Access Compliance Report

Public Rights-of-Way

Intersection ID: 30632	Main Street: PROVIDENCE_RD_WEST	Cross Street: DIXIE_HILLS_DR	Location: SE
ADA ID: 27CCCCF9566CA	Ramp Type: BlendTrans1	Initial Pass/Fail: Fail	Overall Compliance: No
		Severity Score: 10

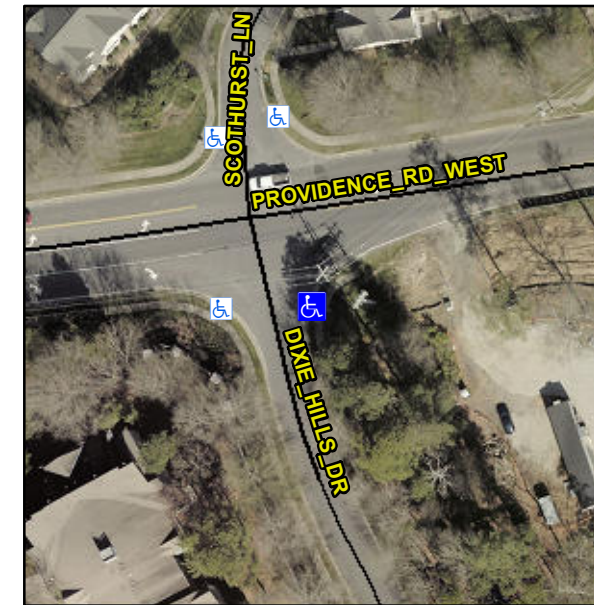
Not Found, R304.5.1, R304.5.3

Compliance	Description	Data	Compliance	Description	Data
N/A	Ramp Length (in)	44.0	Yes	BlendTrans Slope (%)	3.9
No	Ramp Width (in)	46.5	No	BlendTrans XSlope (%)	3.7
N/A	Flare Type LT	N/A	N/A	Flare Type RT	N/A
N/A	Flare Slope LT (%)	N/A	N/A	Flare Slope RT (%)	N/A
N/A	Flare Traversable LT?	N/A	N/A	Flare Traversable RT?	N/A
N/A	Landing Length (in)	N/A	N/A	DWS Provided?	N/A
N/A	Landing Width (in)	N/A	N/A	DWS Contrast?	N/A
N/A	Landing Slope (%)	N/A	N/A	DWS Length (in)	N/A
N/A	Landing X Slope (%)	N/A	N/A	DWS Full Width?	N/A
N/A	Landing Curb? (Y/N)	N/A	N/A	DWS Offset (in)	N/A
N/A	Shared Landing?	N/A			
N/A	Gutter Ponding?	N/A	N/A	Gutter Slope (%)	N/A
N/A	Gutter Lip Ht (in)	N/A	N/A	Gutter X Slope (%)	N/A
N/A	Painted X Walk1?	No	N/A	Painted X Walk2?	No
	X Walk 1 Direction	To N		X Walk 2 Direction	To W
	X Walk 1 Width (in)	N/A		X Walk 2 Width (in)	N/A
	X Walk 1 Slope (%)	3.7		X Walk 2 Slope (%)	3.1
	X Walk 1 X Slope (%)	0.2		X Walk 2 X Slope (%)	4.0

N/A	Ramp inside XWalk1?	N/A	N/A	Ramp inside XWalk2?	N/A
	Road Slope (%)	3.7		Clear Space?	N/A
	Road X Slope (%)	2.5	N/A	Clear Space to XWalk (in)	N/A
N/A	Any Obstructions?	N/A	N/A	Storm Grate/Utility Hazard?	N/A
	Obstruction Type			Storm Grate/Utility Type	
		N/A			N/A
			Yes	Surface Condition? (G/P)	Good
			No	Curb Slope (%)	11.8

Remove & Replace Curb Ramp With Two New Directional Ramps or Equivalent.
